**Sundry Request for Variance
ConocoPhillips Company
WILDER FEDERAL AC COM 28 8H
API #: 30-025-41692**

Lea County, New Mexico

Conditions of Approval
Sundry dated 8/26/2014
Wilder Federal AC Com 28 8H
30-025-41692
ConocoPhillips Company

W .DER FEDERAL AC COM 28 8H – Actual We lbore

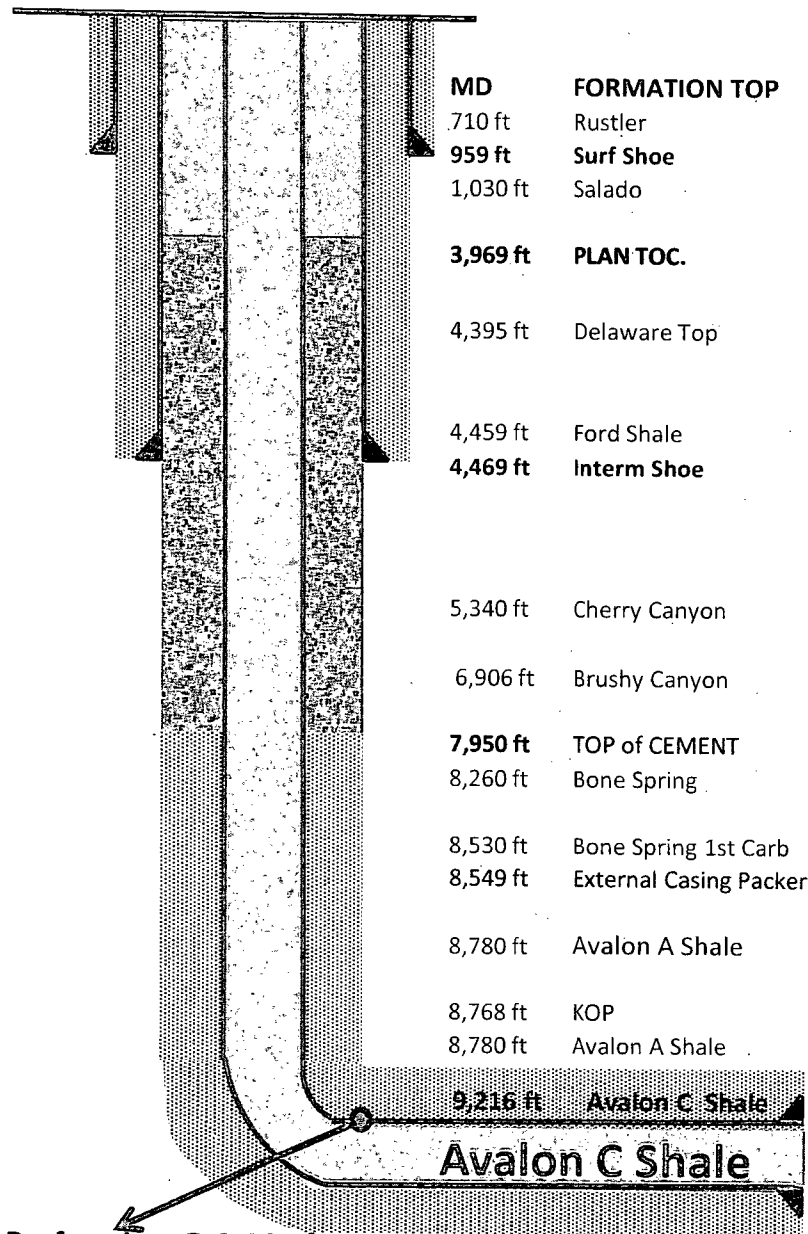
On August 20, 2014, SLB completed 0 psi & 1000 psi pass of CBL with Isolation Scanner logging run per BLM requirements. The CBL log indicates the top of cement to be approximately at 7,950 ft MD shown from the reduction in amplitude. The VDL was not conclusive in determining where the top of cement was located. The additional data from the isolation scanner show some ratty cement from 7,660' MD to 7,710' MD.

- Objective: Provide zonal isolation of production interval and provide medium for stimulation.
- Drill 8-3/4" hole to 15,925 ft - "Production TD".
- Mud Weight: 8.9 – 9.4 ppg Cut-Brine.
- Set 5-1/2" 20# P-110 Ten XP BTC casing**
- Cement lap 500 ft above previous shoe (Plan). Actual TOC @ 7,950 ft.

Note that this is approval to proceed with fracture stimulation and remedial cement work will be required to meet the original APD conditions of approval which is to tie-back cement 500 feet into previous casing string.

1. Operator to notify the BLM at least 36hrs before work is to begin on well.
2. **Step 7 maximum stimulation pressure not to exceed 9,800 psi**
3. **Step 12 CBL shall be run from KOP 8,768MD to surface**
